Document ID 1520260	Version 1.0	Status Approved	Reg no	Page 1 (4)
Author Lars Birgersson			Date 2015-12-10	
Reviewed by Mikael Gontier			Reviewed date 2016-01-13	
Approved by Helene Åhsberg			Approved date 2016-01-18

Adjustments and corrections in the EIS

Figure 7-5 is replaced with the following:

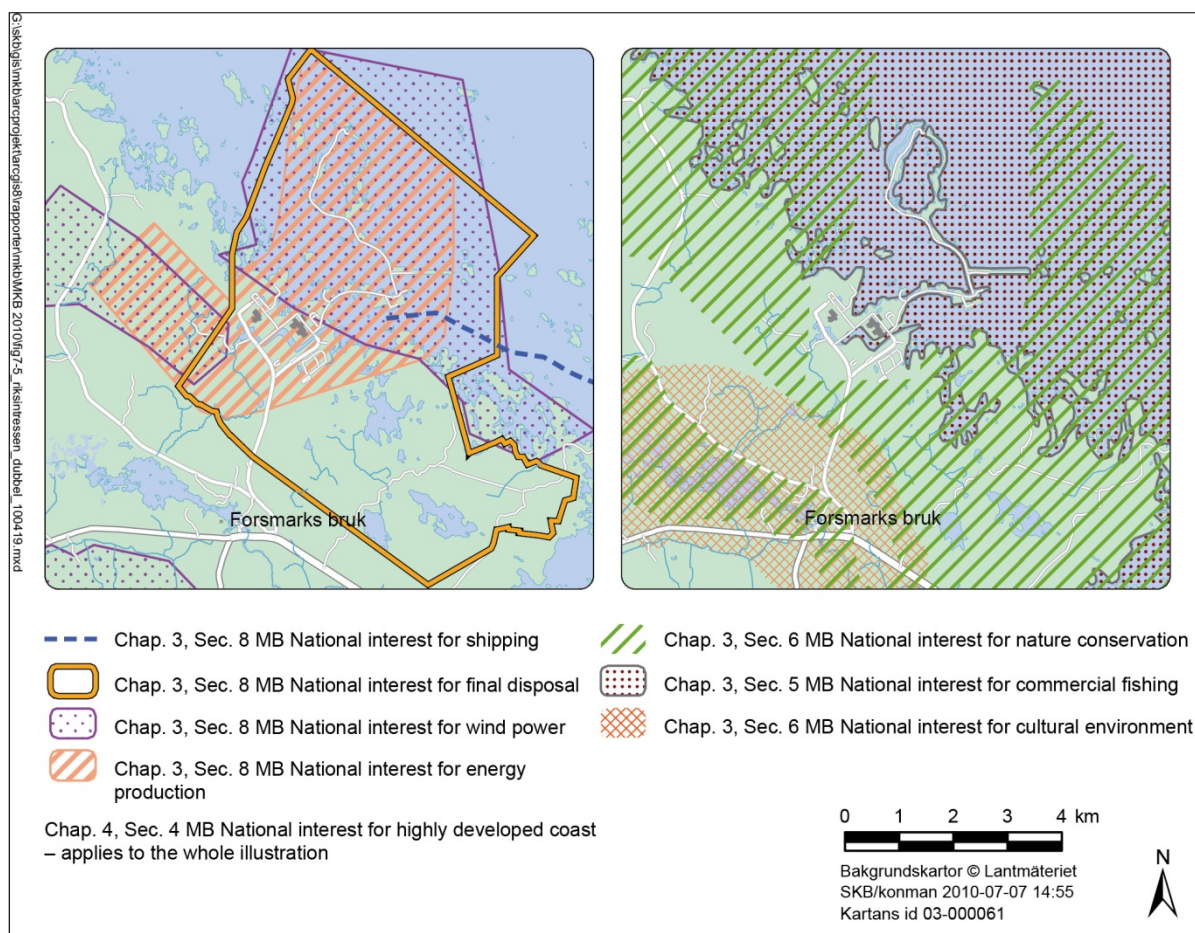
The change that has been made in the figure is that the text about national interests for outdoor activities has been removed.

Figure 10-34 is replaced with the following:

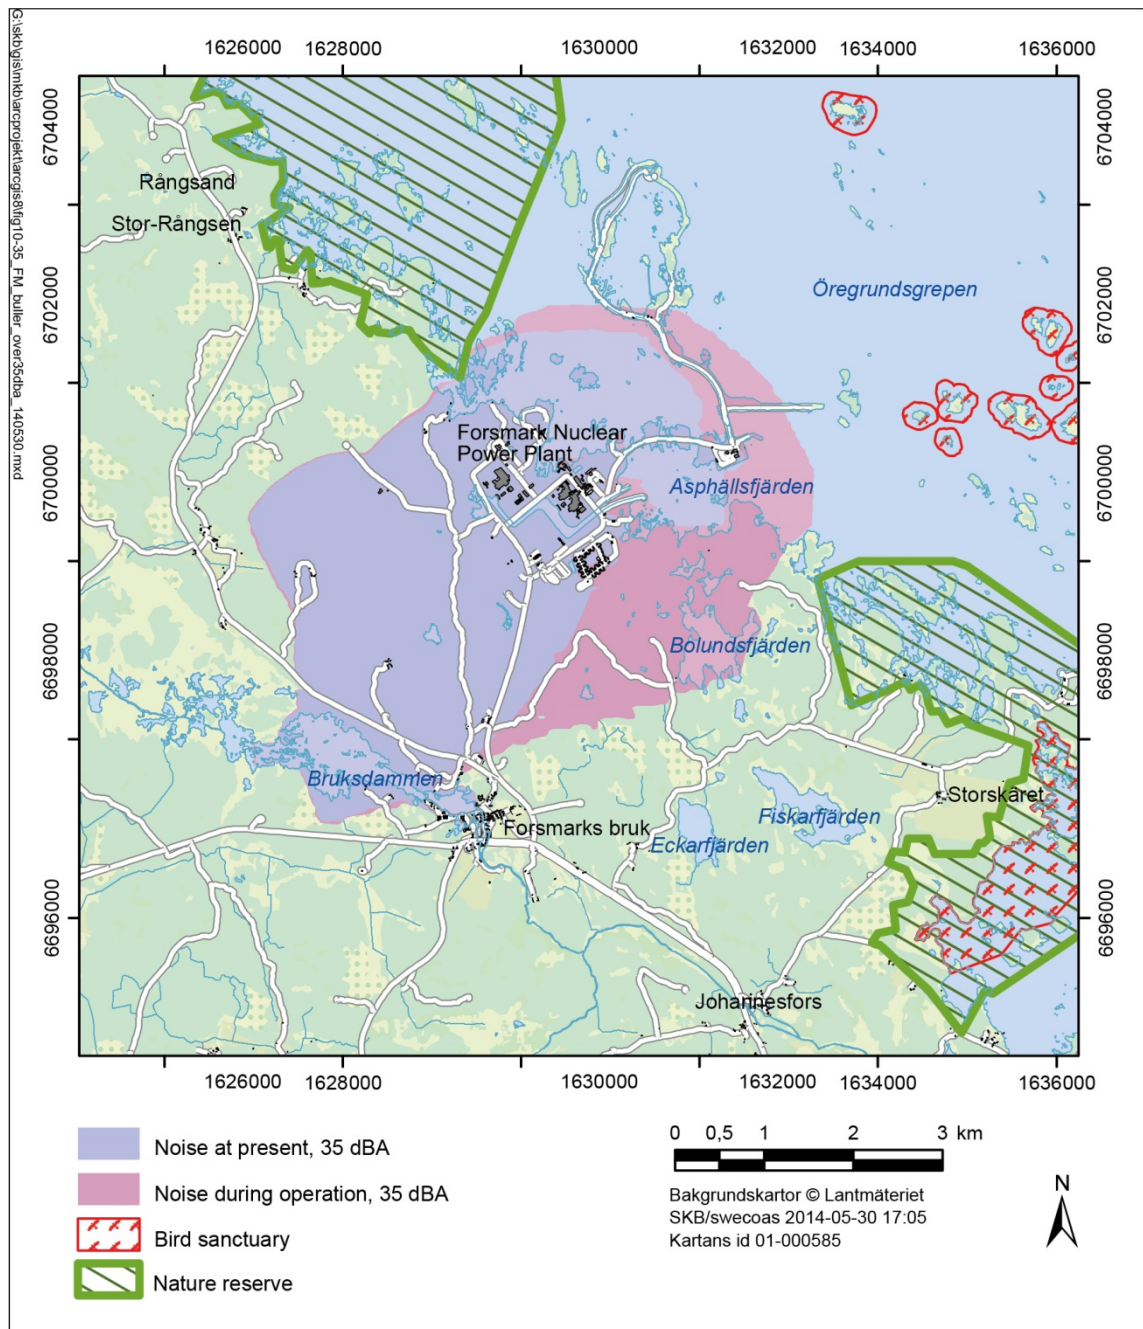
The change that has been made in the figure is that the area marked as a national interest for outdoor activities has been removed.
